NOTICE OF AMENDED ARCHITECTURAL DRAWINGS FOR A MODIFICATION APPLICATION AT 29 SHIRLEY STREET AND 2-4 MILTON STREET, BYRON BAY

Urbis act on behalf of *The Trustee for The 29 Shirley Street Trust* (the *Applicant*) in relation to a S4.55(2) Modification Application to an approval for a Residential Flat Building at 29 Shirley Street and 2-4 Milton Street, Byron Bay (**Council Reference:** 10.2022.371.2) (**Originating Council Reference:** 10.2022.371.1).

Figure 1 Amended Basement Plan

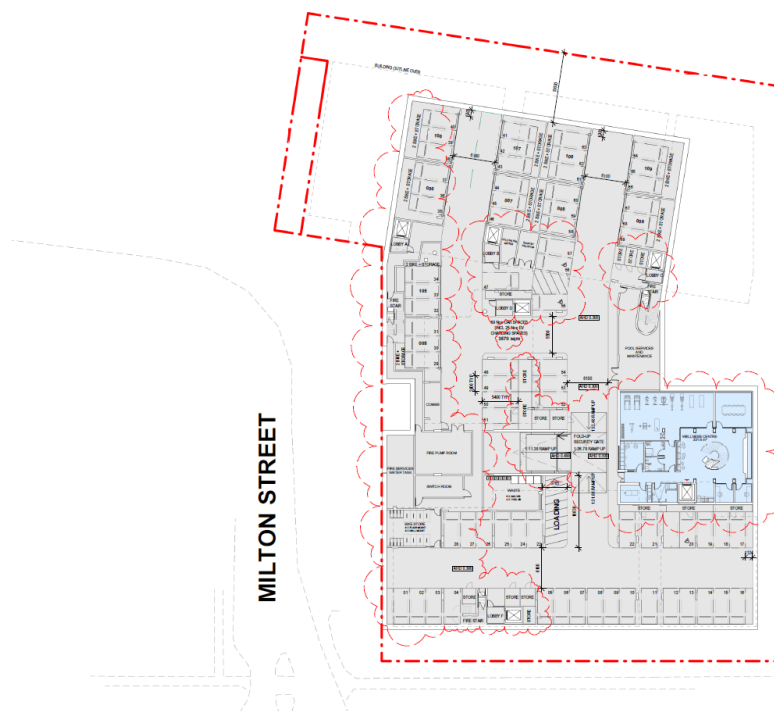
The amended basement plan is shown below in **Figure 1** to illustrate the extent of changes to the building footprint and internal configurations. Notably, the GFA of the basement itself has been reduced from 3,630m² to 3,570m², and the wellness centre reduced from 352.8m² to 331.6m². This has been done in order to increase the setback of the basement to the adjoining lot to the east at 27 Shirley Street.

As illustrated, the eastern side of the wellness centre has been reduced inwards and now sits flush with the front portion of the basement therefore reducing its overall building footprint. Internal modifications such as the deletion of an office space and the reduction of a storage area have facilitated in this reduction. Additionally, there have been no changes to the car parking provisions or bicycle spaces included as part of the submitted scheme.

Figure 2 East Building - Western Elevation

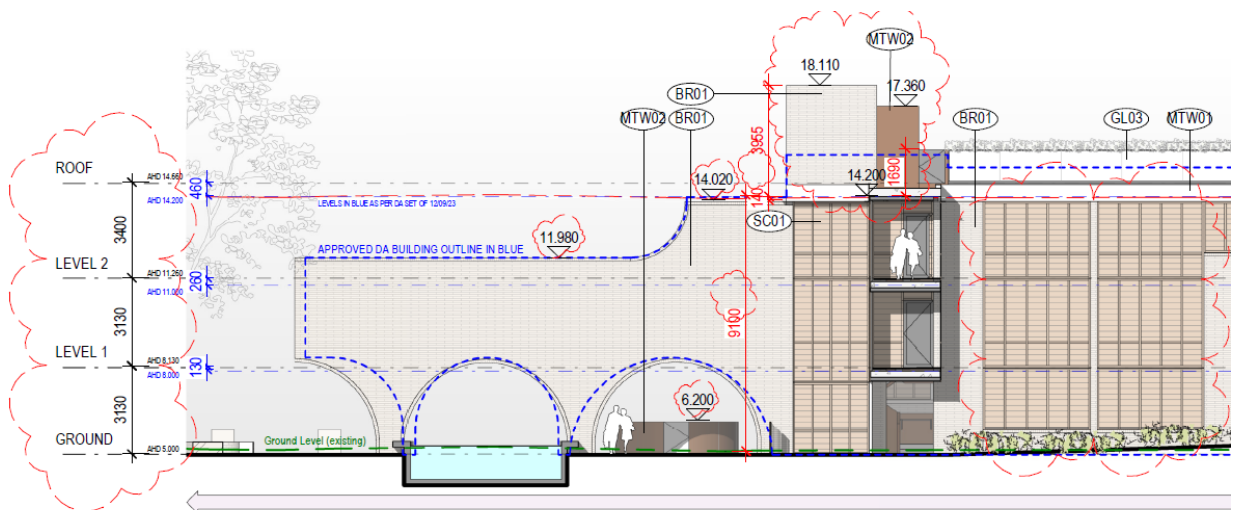
The below **Figure 2** demonstrates the amended western elevation of the eastern building that fronts Shirley Street. This illustrates the changes to the lift shaft which as outlined above, has been extended up to provide access to apartment 210 and the rooftop garden for compliant DDA access.

The addition of the lift shaft extent as included within the further amended package results in a total building height of 13.05m within this portion of the building only within the R3 zoned land. This is an equivalent increase of 45% above the 9m building height line. Importantly, this proposed increase is consolidated to the one location to facilitate the increased lift shaft, with the balance of all building heights to remain the same as originally submitted as part of the modification application.

Figure 3 South Elevation - Shirley Street

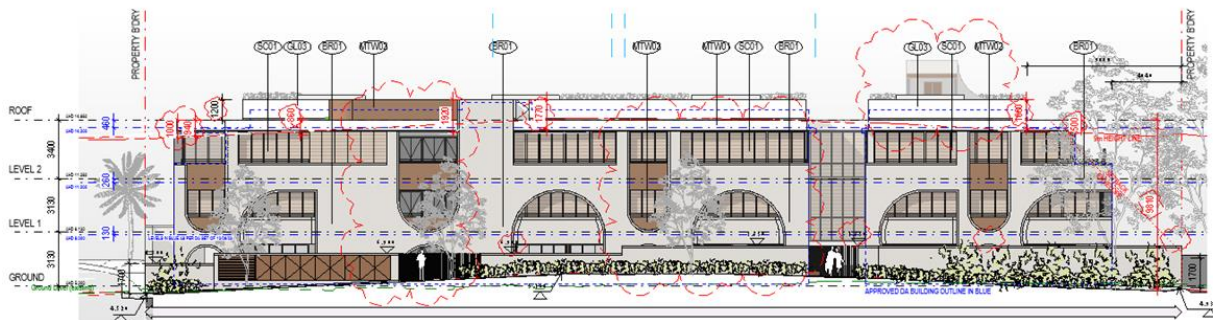
The amended southern elevation is shown in **Figure 3** below to illustrate the extended lift shaft from the frontage. As demonstrated, the lift shaft extent is situated outside of the setback envelope and will have minimum visibility from a streetscape level from Shirley Street as it is largely setback behind the private rooftop terrace. From a streetscape perspective, pedestrians travelling along Shirley Street will be unable to view the lift shaft.

Additionally, from this perspective, the extended lift shaft does not add any additional bulk or massing to the proposal overall as it is largely concentrated to one minor location behind the private open space of apartment 201.
